Service Bulletin

MEB09-2

MAIN LANDING GEAR TORQUE TUBE LIFE LIMIT

Figure 1. MLG Torque Tube Replacement (Sheet 1)

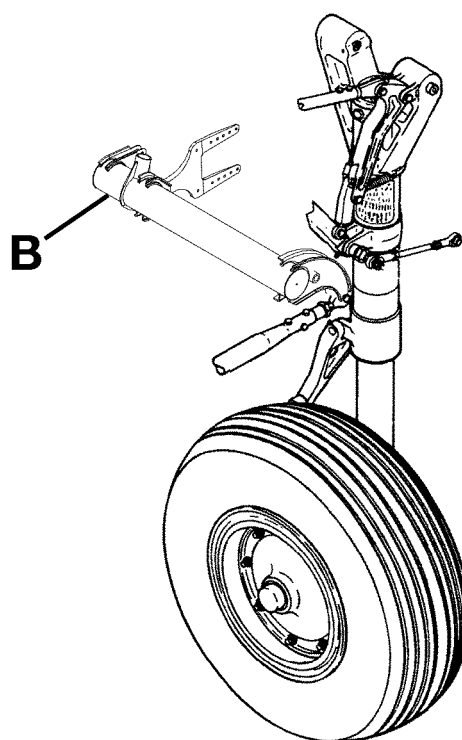
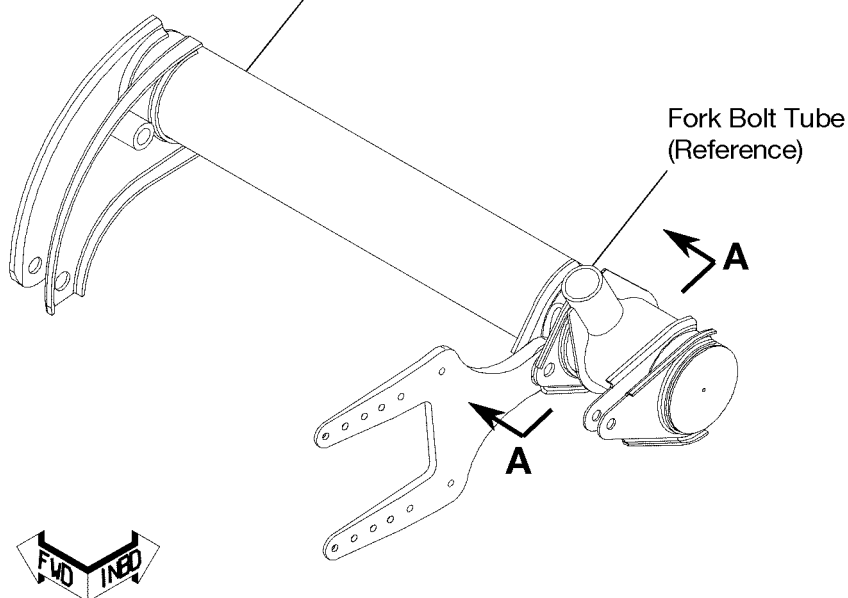
- B. (Refer to Figure 1, View A-A.) Examine the brace on the fork bolt tube.
 - (1) If there are no braces on the tube, the torque tube assembly installed on your airplane is not a 5045010-32 Right Torque Tube Assembly or a 5045010-33 Left Torque Tube Assembly. Go to Step 5.

- (3) If there are two braces on the tube, go to Step 4C.
 - C. Measure the outer diameter of the fork bolt tube:
 - (1) If the outer diameter of the tube is approximately 0.91 inch, the torque tube assembly installed on your airplane is a 5045010-32 Right Torque Tube Assembly or a 5045010-33 Left Torque Tube Assembly. Go to Step 9.

- (2) If the outer diameter of the tube is approximately 0.68 inch, the torque tube assembly installed on your airplane is not a 5045010-32 Right Torque Tube Assembly or a 5045010-33 Left Torque Tube Assembly. Go to Step 5.

5. Return the airplane to service as follows:
- A. Put the airplane on jacks. (Refer to the applicable section of the service/maintenance manual.)
 - B. (Refer to Figure 1, Detail A and Detail B.) Remove the 5045010 Torque Tube Assembly from the airplane. Keep the attachment hardware, but discard the nuts and the cotter pins. (Refer to the applicable section of the service/maintenance Manual.)

5045010-33
Left Torque Tube Assembly (Shown)
5045010-32
Right Torque Tube Assembly (Opposite)
(1 Each If Required)
